RE: San Pedro Hills POADP
File #86-17-63-20

This is to inform you that the POADP committee has reviewed and accepted your plan of San Pedro Hills.

SAN PEDRO HILLS - UNITS 21 - 25

PRELIMINARY OVERALL AREA DEVELOPMENT PLAN (POADP)

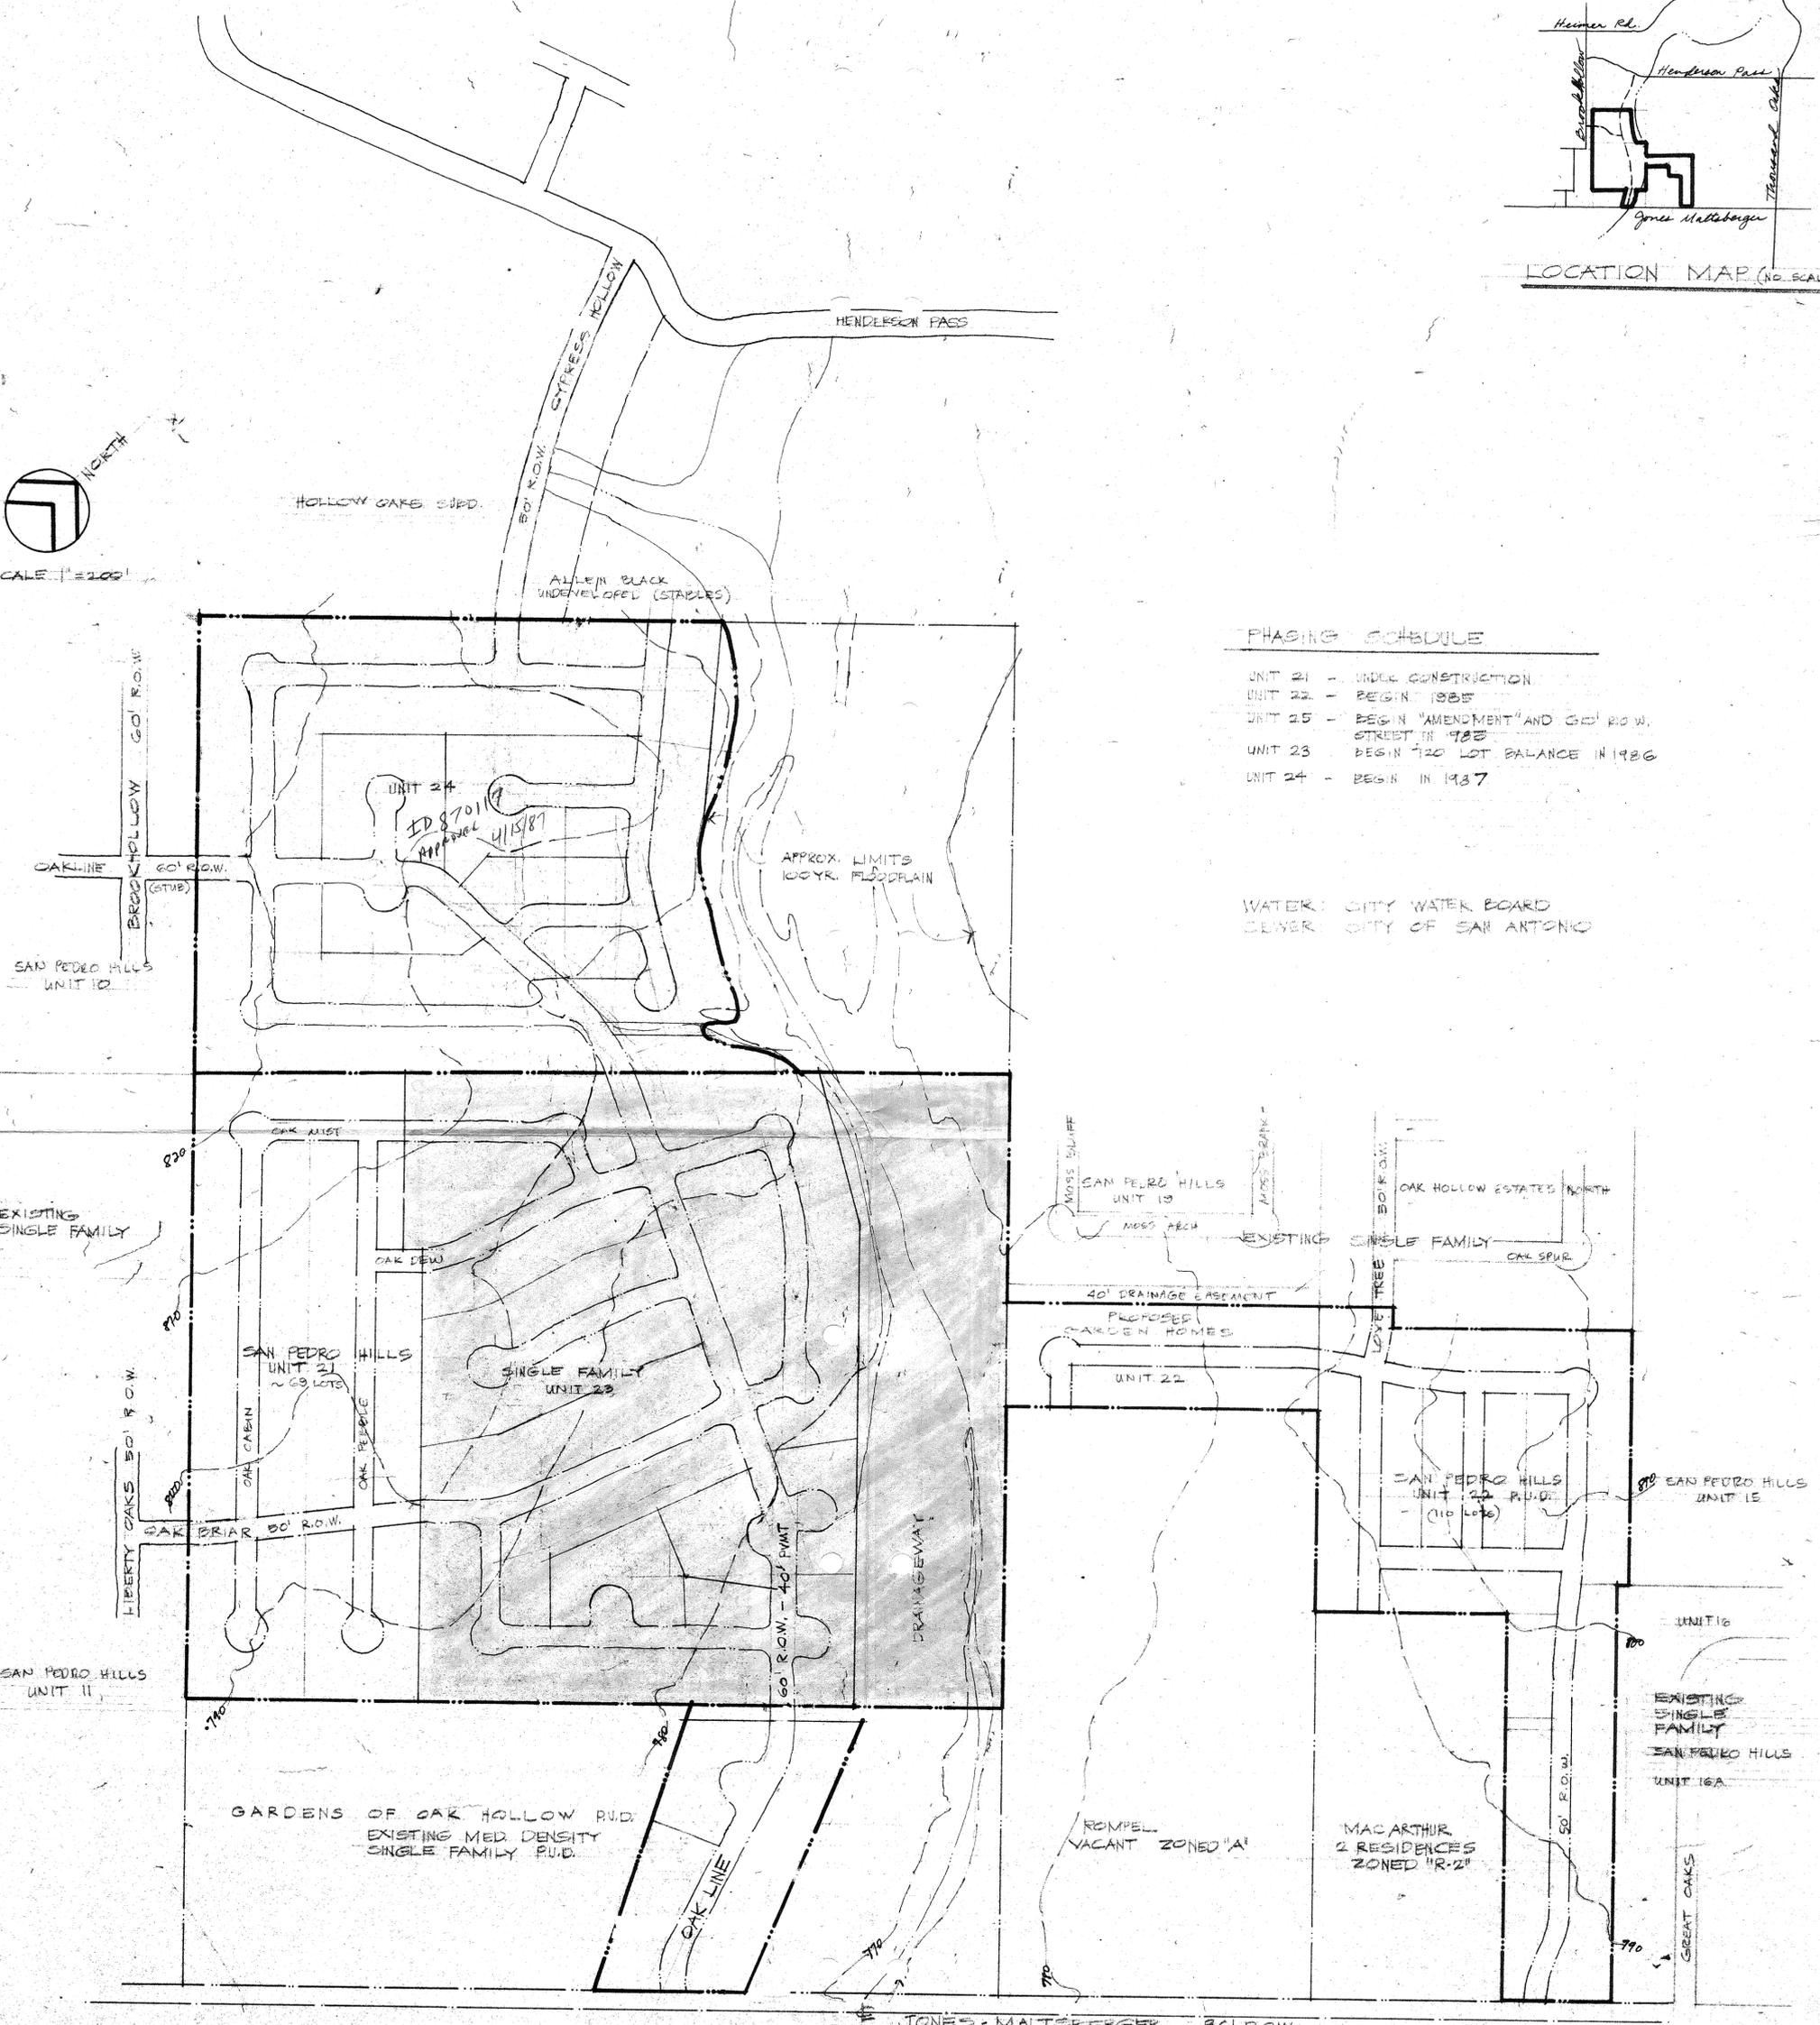
The POADP Committee would like to thank you and Mr. Denton for meeting with us on March 1, 1985 and discussing the San Pedro Hills Plan. The Committee has since reviewed and accepted your latest proposal which reflects the realignment of Cypress Hollow to offset direct access to Oakline Drive.

As discussed in our meeting with you on March 1, 1985, staff has no objections to the new proposed street alignment (60' R.O.W., 40' paving) which links Jones Maltsberger and Oakline Drive. However, we ask that consideration be given to reduce the number of residential lots fronting onto the proposed 60' R.O.W. which are planned near Brook Hollow. Traffic Engineering objects to the direct connection of Cypress Hollow to the Oakline extension as shown of the POADP. Therefore, request you redesign that street to reflect a more indirect routing.

It is noted that staff review was focussed on Units 21-24. In regards to the planned north-south local type "B" street, it will be necessary to upgrade said street to a collector standard. As previously mentioned to you on a prior occasion said street will facilitate expected traffic volumes between Jones-Maltsberger and Henderson Pass.

Comment: Amended street alignment is acceptable.

Please be advised that the review of the Preliminary Overall Area Development Plan (POADP) for San Pedro Hills Unit Twenty One (File #83-17-63-20) has been completed. Staff review concludes that the planned development concept is in general compliance with Chapter 36 of the City Code. However, it is noted that Jones Maltsberger Road is classified as a secondary arterial type "A", 86' R.O.W. street, on the current Major Thoroughfare Plan. Therefore, any platting activity occurring along said thoroughfare will require dedication for future street widening in accordance with the aforementioned plan.
